8373 Black Walnut Drive

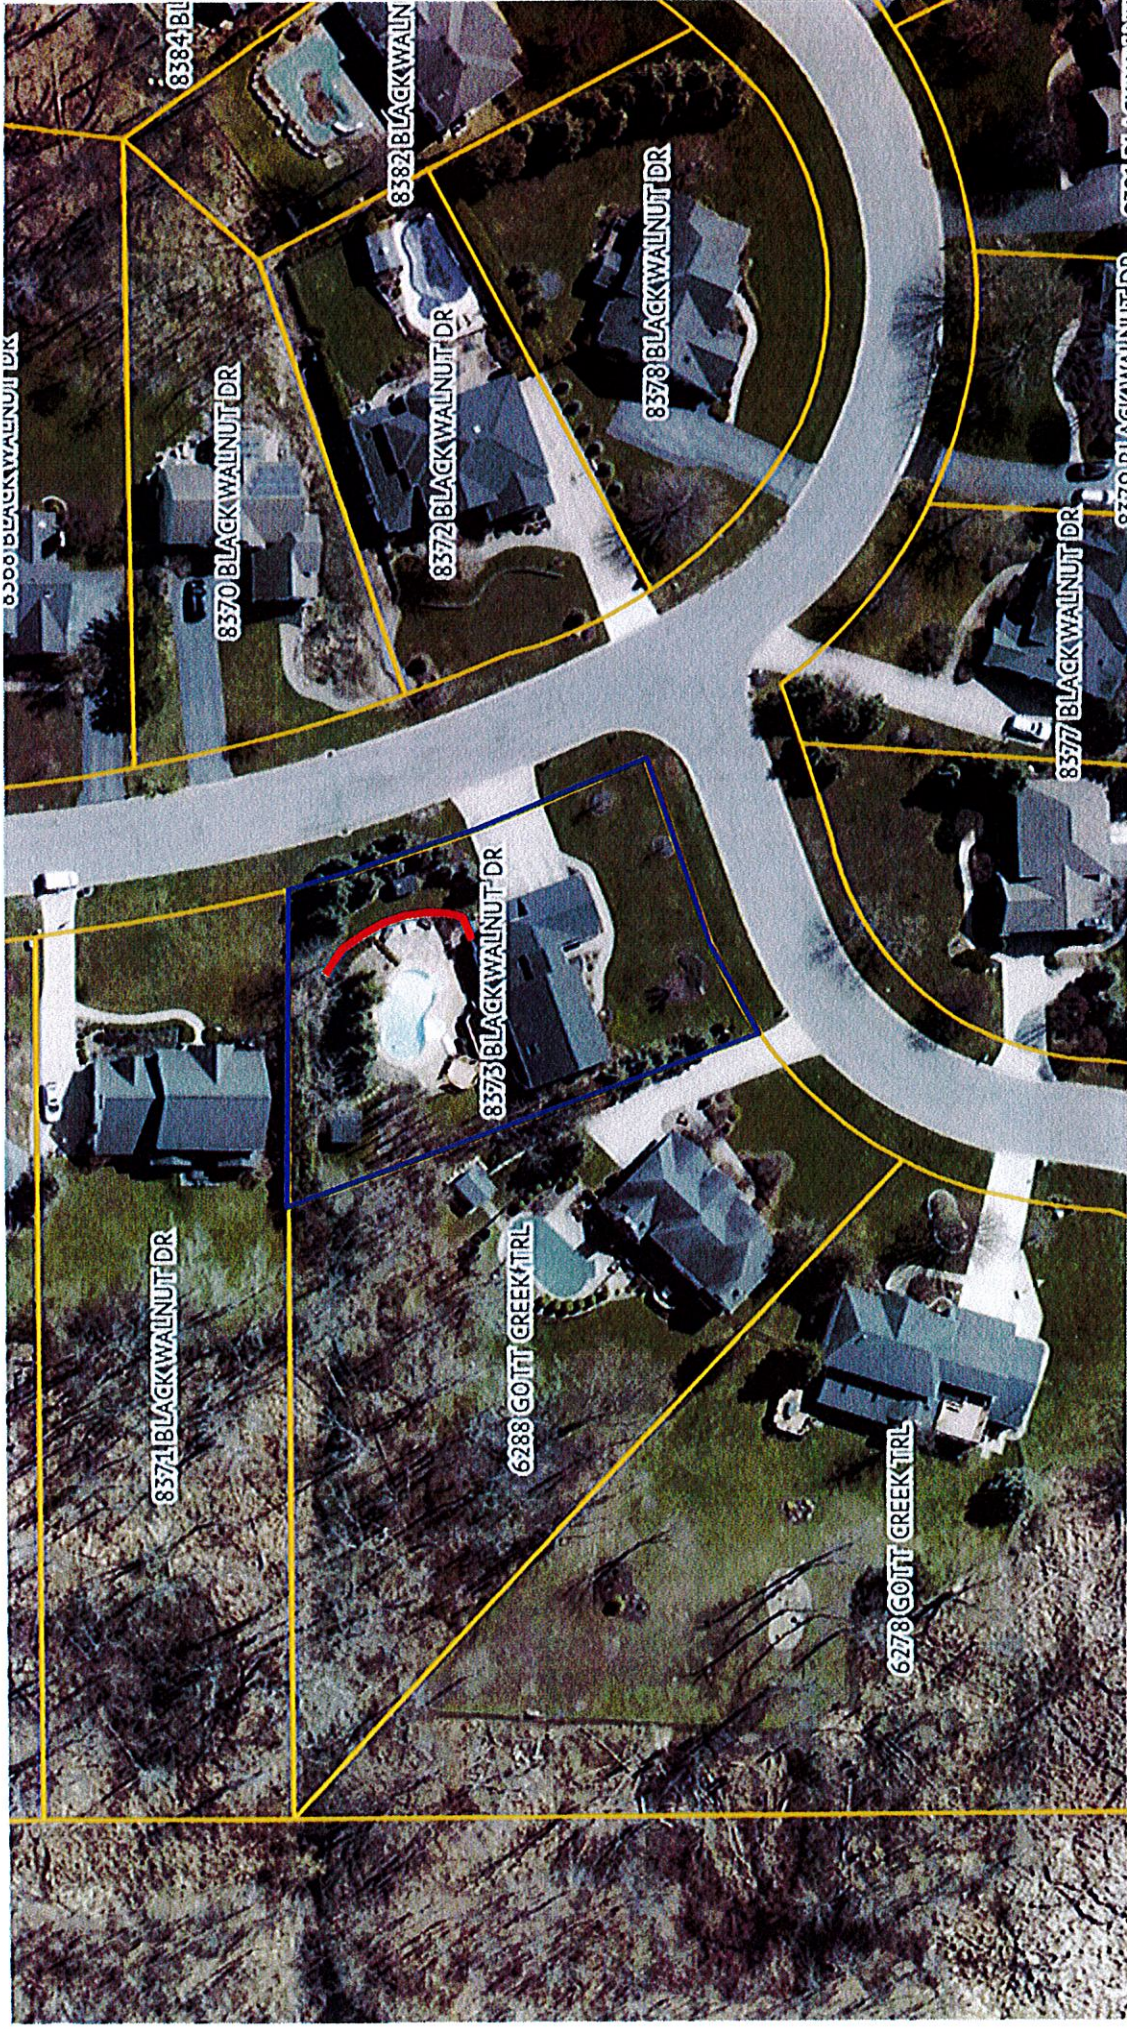
Proposed 6' fence to be located within front yard. The maximum allowed height for a fence extending into the front yard is 4'. A 2' variance is requested.
